**Re:** **Application by – Chen Design Studio for Development Permit at  
7900 Bennett Road**

### 2. Development Permit 10-545704

## Report to Development Permit Panel

**Re:** **Application by Chen Design Studio for a Development Permit at 7900 Bennett Road**

Drawing Title:  
**SITE PLAN & DATA**

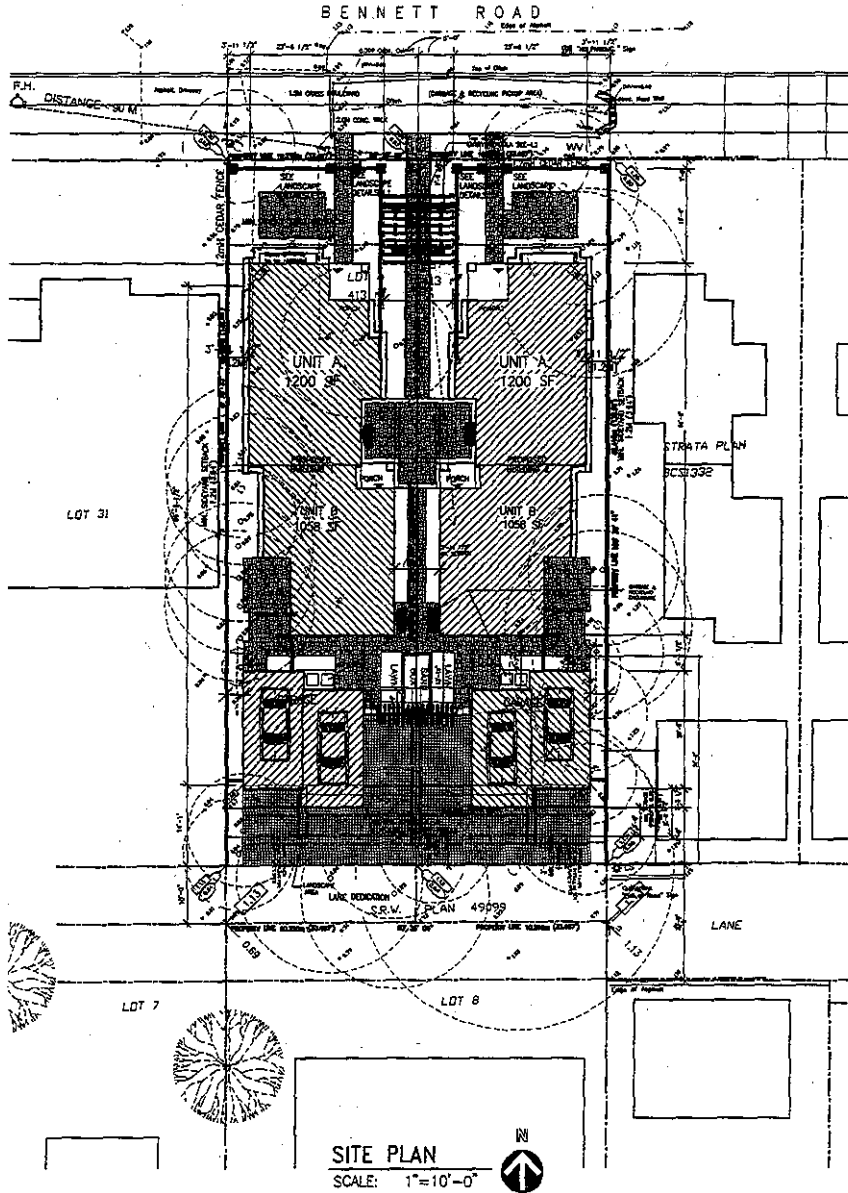
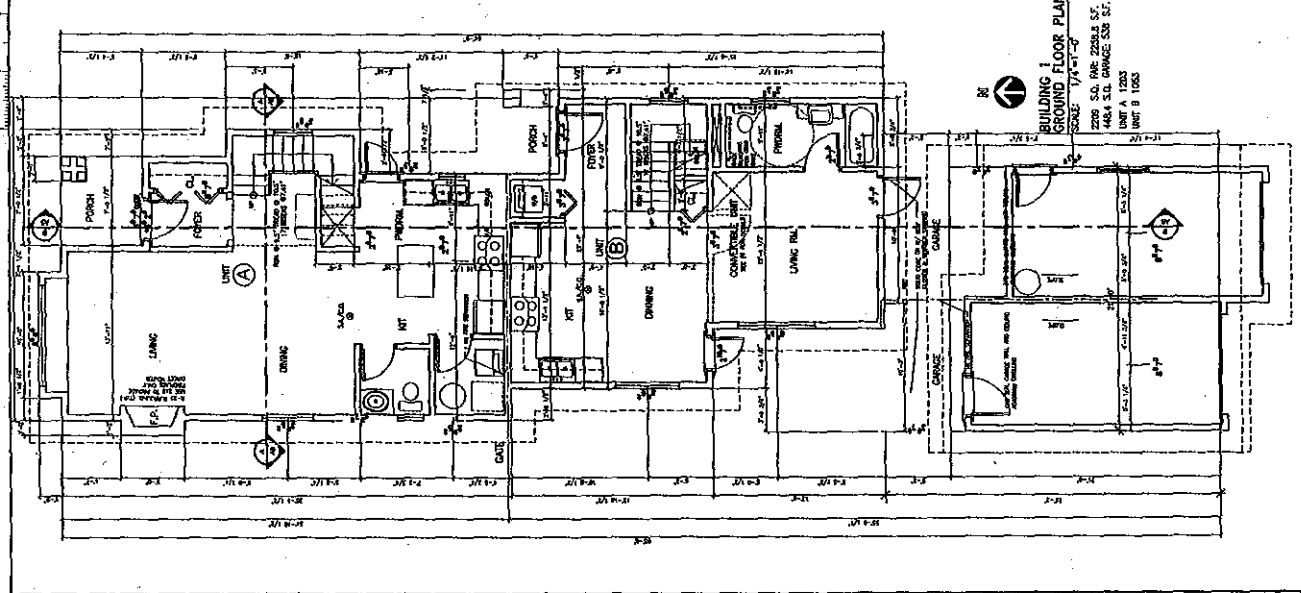
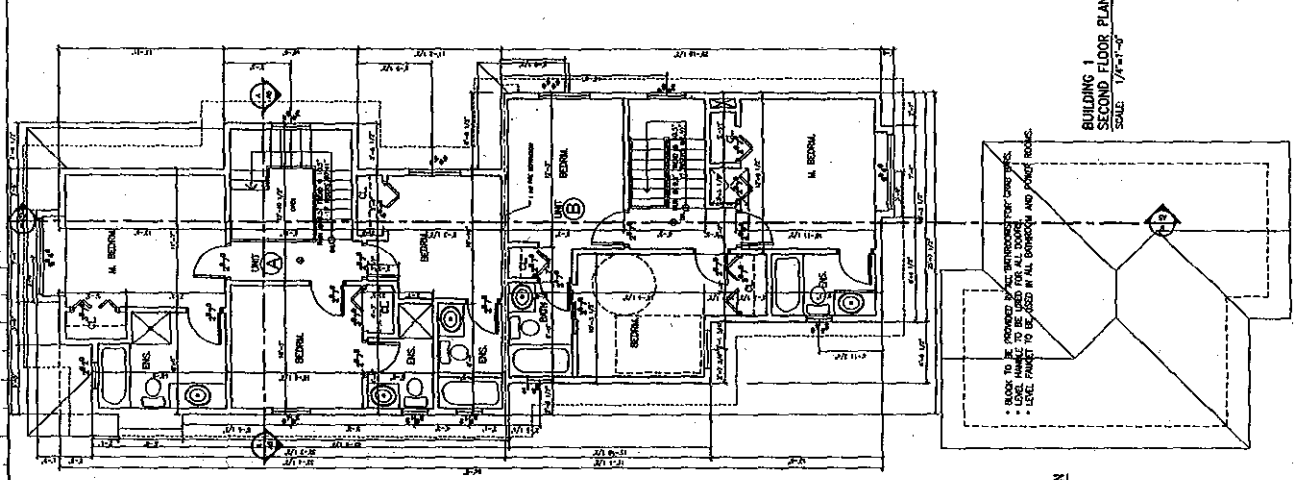
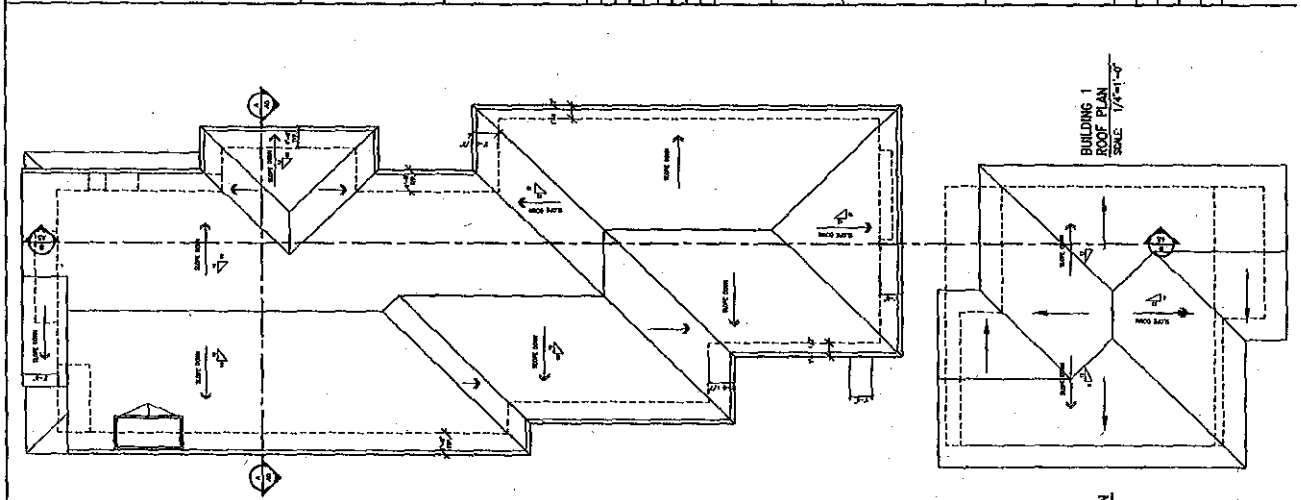
- all parking is at the rear of the subject site, and a pathway in the centre of the site features some low landscaping to soften the edges;
- the proposed fence could be relocated further toward the north, to allow the addition of more landscaping elements;
- the access from the lane is a hard surface;
- no outdoor amenity space is provided on site, but the project is located close to the City's Brighthouse Park, an area that offers outdoor space; and
- fencing the perimeter is a questionable solution to adjacency issues.

Discussion continued with the Panel questioning the appropriateness of: (i) a lack of outdoor space; (ii) reliance on Brighthouse Park for outdoor activity for children; (iii) questionable safety for children leaving the subject site and going to Brighthouse Park for play; and (iv) the general lack of quiet outdoor space on the subject site.

The Chair stated that the project's design could be more appropriate and more sensitively executed in terms of: (i) landscaping; (ii) presentation to the lane; (iii) whether there is a way to make access to the site, and parking, more workable; and (iv) the provision for usable outdoor space for each unit.

- (i) the landscaping scheme;*
- (ii) presentation to the lane;*
- (iii) access to the site;*
- (iv) on-site parking; and*
- (v) provision of useable outdoor space for each unit.*

- the garages have been: (i) detached from the principal building to create more amenity space; and (ii) shifted to improve access;
- a lattice fence had been developed to make the amenity space more open and more useable by residents; and
- revisions have been made to the landscaping scheme by making more planting area available.

In response to the Chair's question, the applicant confirmed that the garages are now detached, not attached to residential units, so that each residential unit now had a rear yard space.
